Our Ref: JAG//43386/Lt004

**Re: Proposed Development at Bicester Gateway: LLFA Response**

Following our detailed discussions and e-mails regarding flood risk and drainage matters in relation to the planning application for Bicester Gateway, reference 20/00293, we summarise our response below.

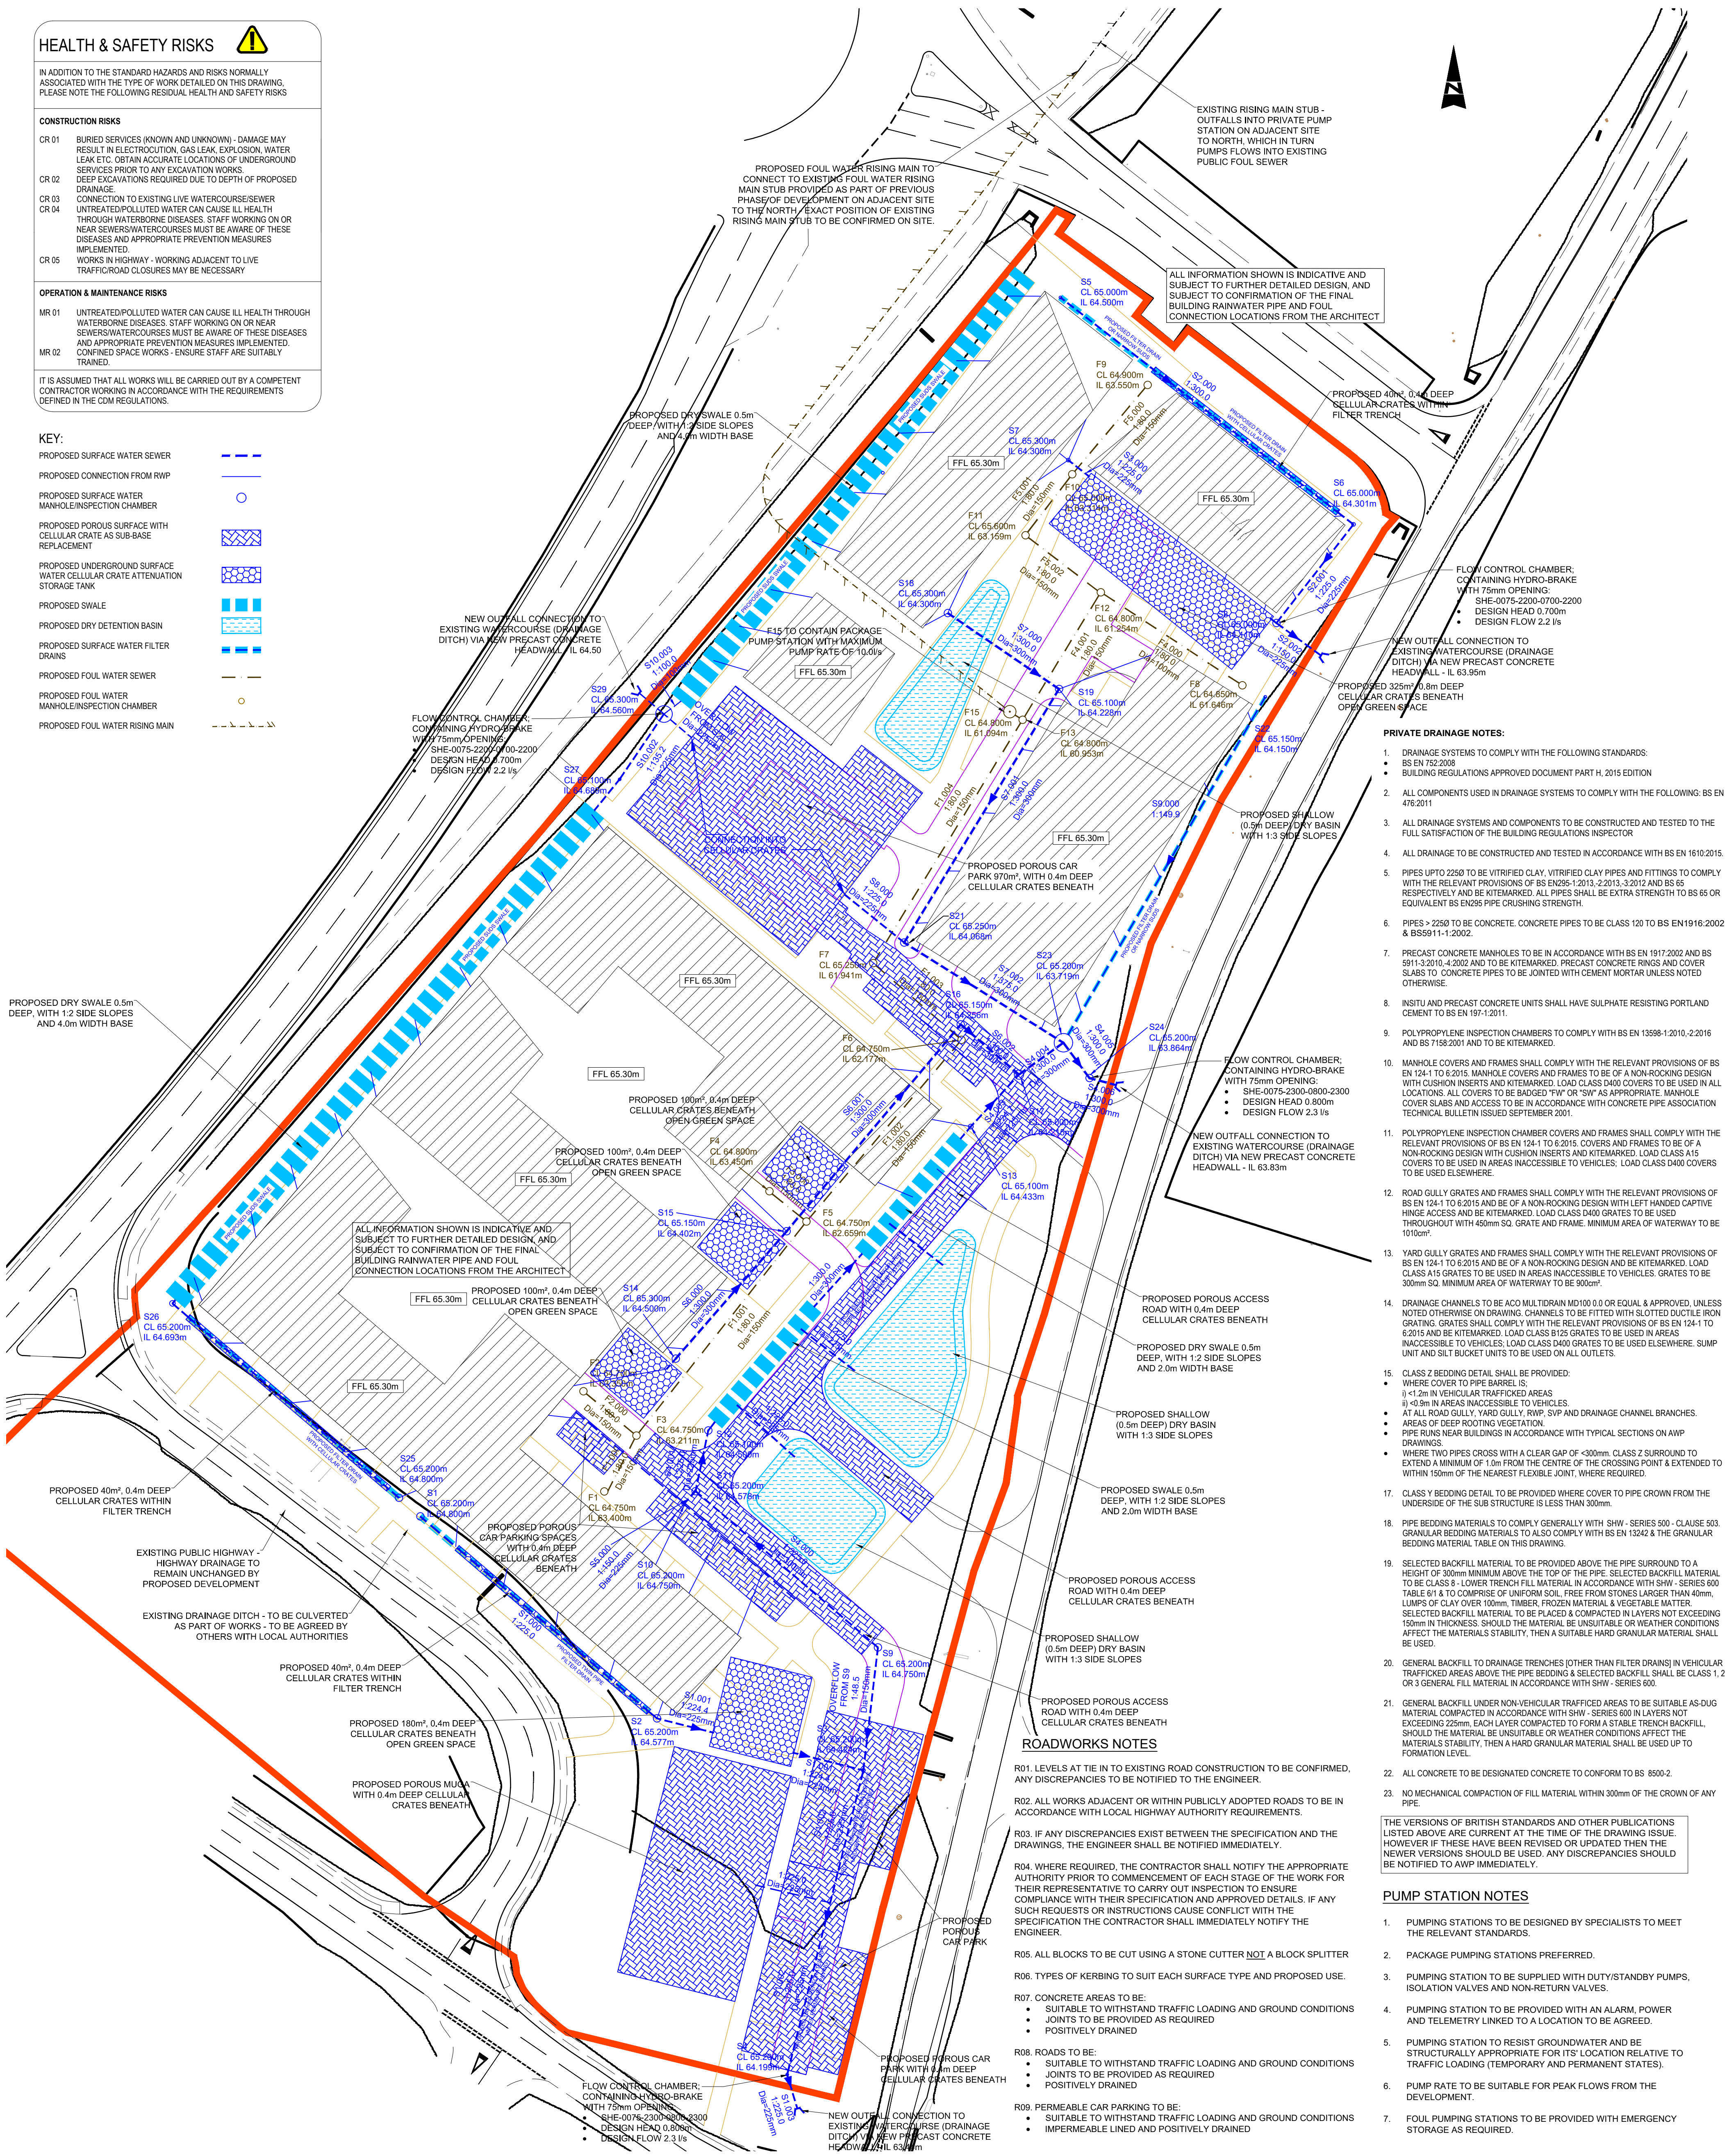
The updated Drainage Layout and supporting Calculations have been updated to allow for shallow, non-pumped connections to adjacent watercourses.

Due to the size of the site, and the shallowness of the watercourses it is not feasible to drain to a single outfall via gravity. The site is therefore proposed to outfall to multiple outfalls to enable connection by gravity.

Discharge from each outfall will be restricted by use of flow control devices. The discharge from each outfall will be reduced to the lowest rate practicable, via vortex type flow control devices with 75mm opening. Any smaller opening size would mean a high risk of blockage, which could lead to a flood risk to the site.

Extensive use of shallow SuDS is proposed due to the shallow outfalls to the shallow watercourses. Surface water will be treated and excess flows will be stored via tree pits, swales, filter trenches, permeable paving and detention areas. Due to the site constraints, geo-cellular crates could provide the attenuation storage beneath permeable and paved surfaces, as these have a higher void ratio than open graded sub-base material.

P5	DRAINAGE DESIGN REVISED TO OMIT PUMP AND INCLUDE MORE SUDS	18.06.20	JP	JAG	JAG
P4	DRAINAGE AMENDED TO ACCOMMODATE A +40% CLIMATE CHANGE ALLOWANCE, PROPOSED FFLs AMENDED	30.04.20	JP	JAG	JAG
P3	DRAINAGE ADJUSTED TO SUIT TREE SURVEY AND 'PRESERVATION' ZONE REQUIREMENTS	28.01.20	JP	JAG	JAG
P2	INDICATIVE FFLs ADDED	15.01.20	JP	JAG	JAG
P1	FIRST ISSUE	06.01.20	JP	AD	JAG
Rev	Description	Date	By	Chk	App
